## SERVICE BULLETIN MAINTENANCE OF WAY EQUIPMENT

**DATE:** 4-17-2002 **BULLETIN NO:** 02-014

**TITLE:** H5463XAA PROXIMITY SWITCH CONVERSION GROUP

**PRODUCT SERIES / MODEL:** MKIV and MKVI Tampers

**FIGURE 1  
PROXIMITY SWITCH CONVERSION**

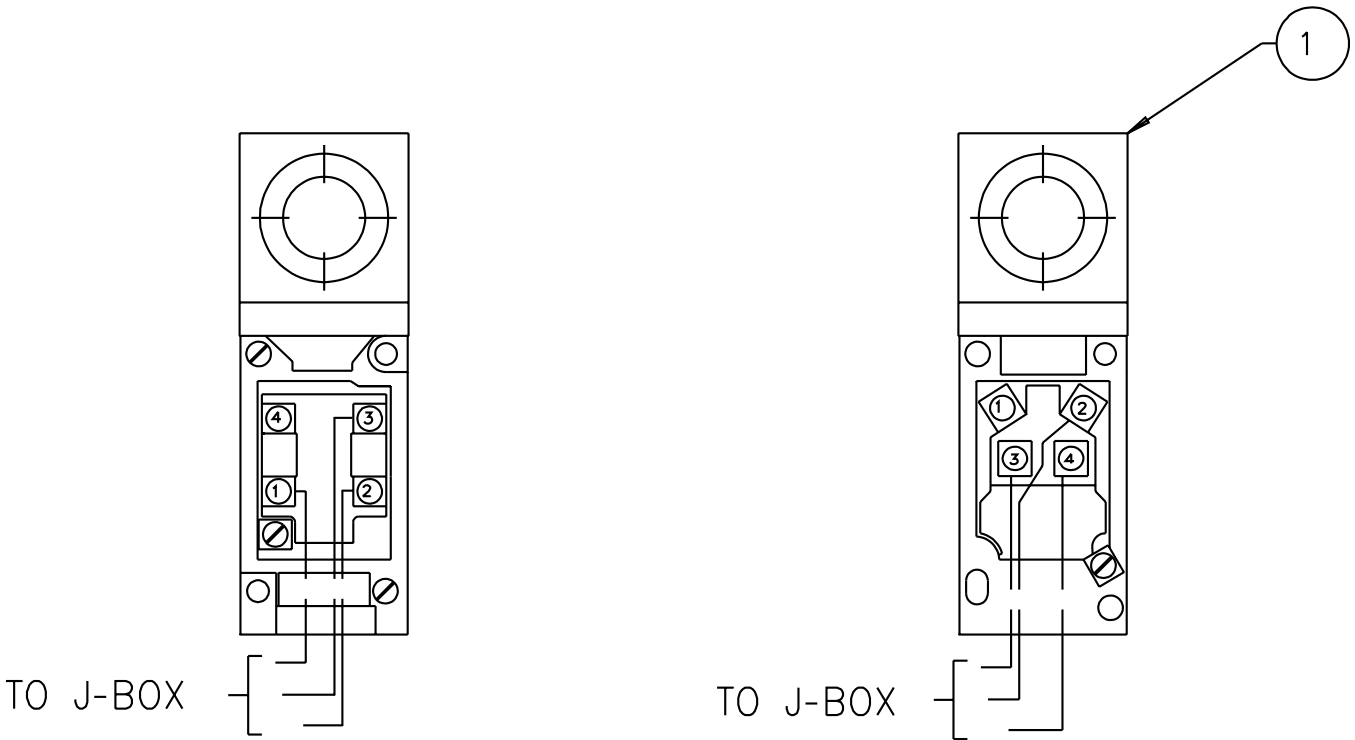
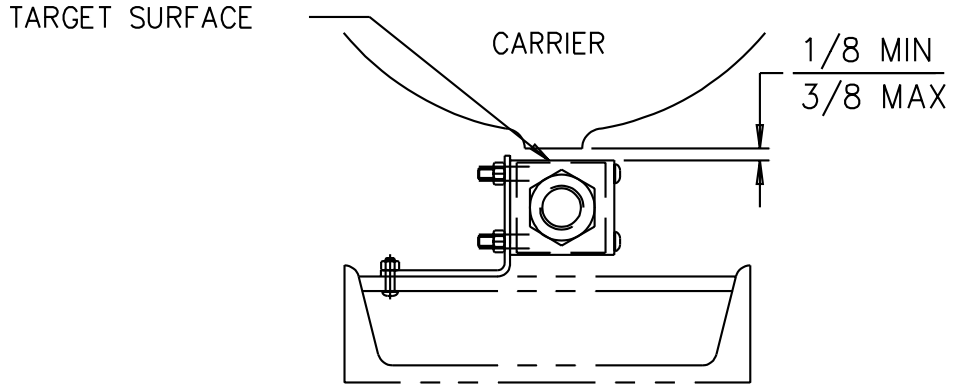
**SUMMARY:** The proximity switch part # 0-3110025-0-11 used on the MKIV and MKVI workhead circuit is no longer being manufactured. An alternate proximity switch part # 0-3110025-0-29 has been tested and is now available as a direct replacement.

1. Locate the existing proximity switch on the workhead
2. Disconnect the electrical wires from the existing proximity switch. Then remove the existing proximity switch from the workhead and discard.

3. Install the new proximity switch (1) on the workhead. Re-connect the electrical wires to the new proximity switch (1) as follows:
  - 3.1 Connect the signal wire from the old switch #1 NO (normally open) contact to the new switch #2 NO (normally open) contact.
  - 3.2 Connect the ground wire #000 from the old switch #3 (-) VDC contact to the new switch #4 (-) VDC contact.
  - 3.3 Connect the power wire #286 or #289 from the old switch #2 (+) VDC contact to the new switch #3 (+) VDC contact.

*Note: The new switch #1 NC (normally closed) contact is not used.*

4. Rotate the head of the new proximity switch (1) so the sensing face is towards the carrier. Apply a small drop of blue Loctite to the screws that mount the sensing head to the switch body and then tighten securely.
5. Start the engine.
6. Verify proper operation of the new proximity switch. When metal is placed within the sensing range of 1/8 - 3/8 inch (3.18 - 9.53 mm) of the proximity switch, the "NC SWITCH CLOSED" red LED will go out and the "NO SWITCH CLOSED" red LED will come on.

OLD STYLE SWITCH WIRING  
HONEYWELL MPS31HD

- 1 - NO (NPN)
- 2 - (+) VDC
- 3 - (-) VDC
- 4 - NC (NPN) (Not Used)

NEW STYLE SWITCH WIRING  
CUTTLER-HAMMER E51SNL

- 1 - NC (NPN) (Not Used)
- 2 - NO (NPN)
- 3 - (+) VDC
- 4 - (-) VDC
